Re: Colusa Generating Station Project: Docket No. 06-AFC-9

Responses to Data Requests 126 Through 129

Application for Certification (06-AFC-9)

COLUSA GENERATING STATION (06-AFC-9) DATA REQUESTS

Figure 128-1
Location of Fugitive and Combustion Volume Sources and Fence Line

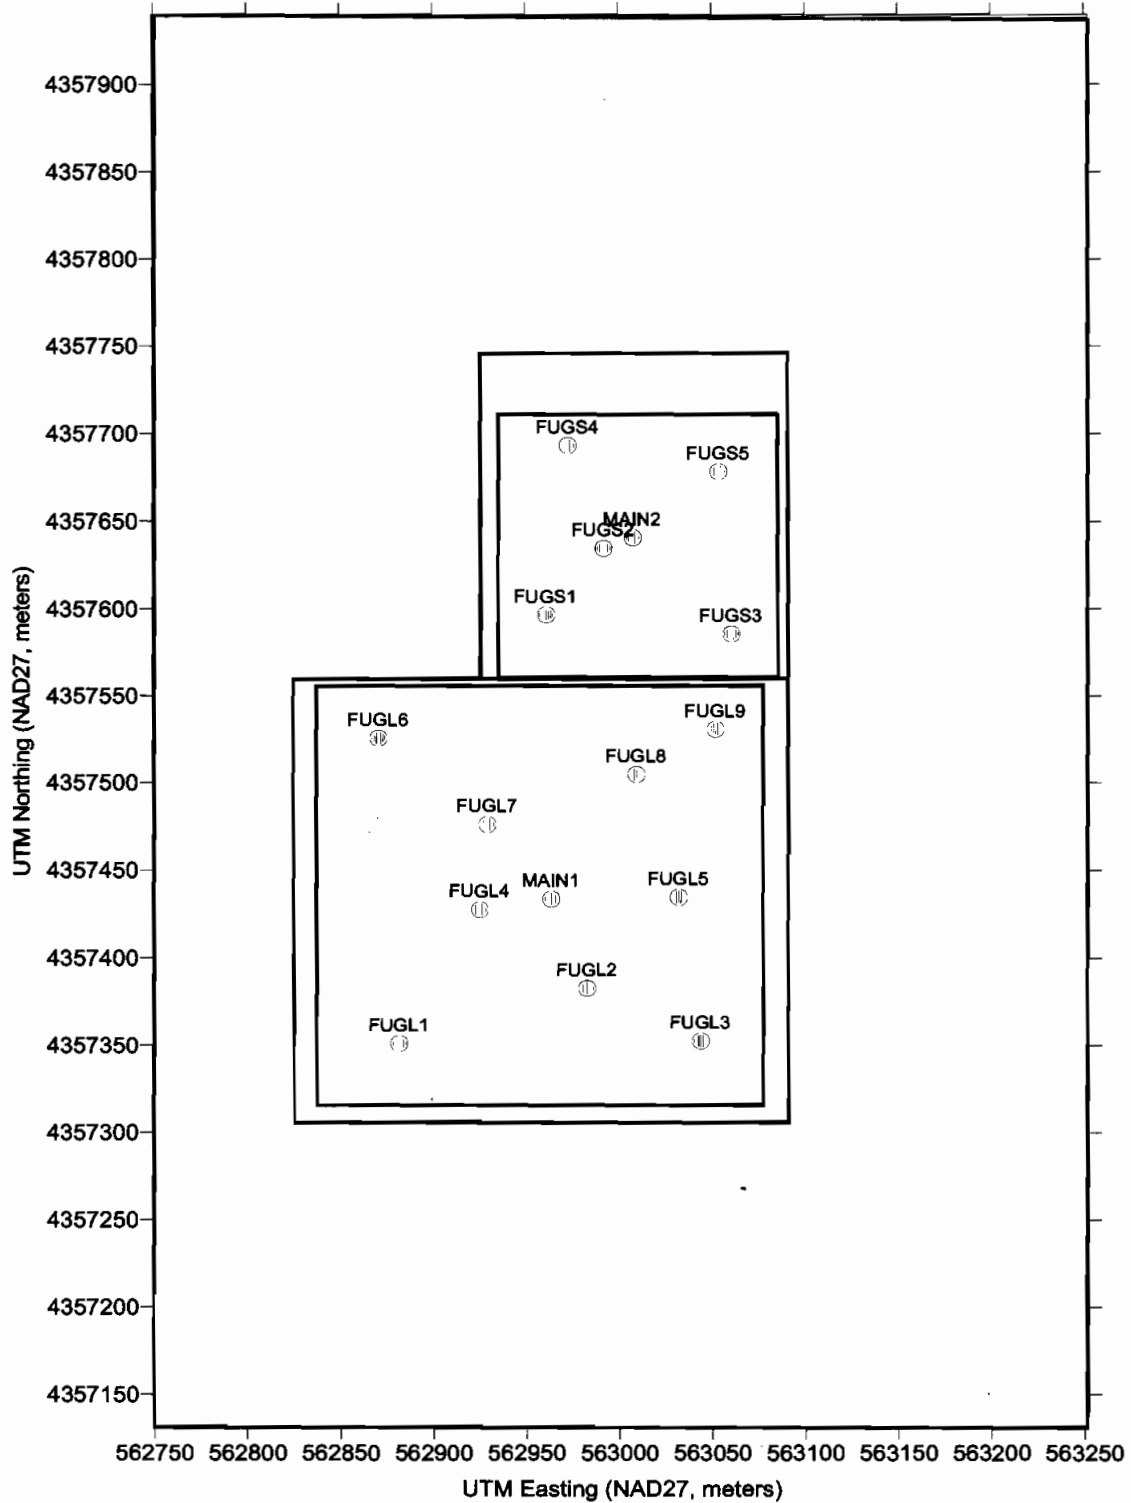
- 128. Please provide a refined construction PM₁₀/PM_{2.5} modeling analysis using volume sources to model the fugitive dust emissions. This can be done either using the same parameters and locations as used for the equipment exhaust PM emissions or another number of volume sources can be distributed around the main construction working area of the project site. Please provide an electronic copy of the modeling input and output files with the response.**

The PM₁₀ and PM_{2.5} impacts of fugitive dust and the particulate matter fraction of the construction equipment combustion exhaust were predicted using the EPA-approved AERMOD dispersion model for the near-field. All fugitive and combustion sources were modeled as volume sources as requested in the data request. The combustion sources (Main 1 and Main 2) were placed in the center of each area as depicted in Figure 128-1. The fourteen (14) fugitive dust sources (FUGL1 through FUGL9 in Area 1 and FUGS1 through FUGS5 in Area 2) were randomly placed as shown in Figure 128- 1 throughout the large area and the small area, respectively. The release height of the fugitive sources were all set to 3 meters based on the averaged height between the maximum fugitive source height (6 meters) and the ground level (0 meters). Initial lateral dimension of the fugitive sources of 23.26 meters and was calculated based on length of side (50 meters) divided by 2.15. The initial vertical dimension of 2.79 meters and was calculated based on vertical dimension (6 meters) of source divided by 2.15. The source location and parameters are shown in Table 128-1.
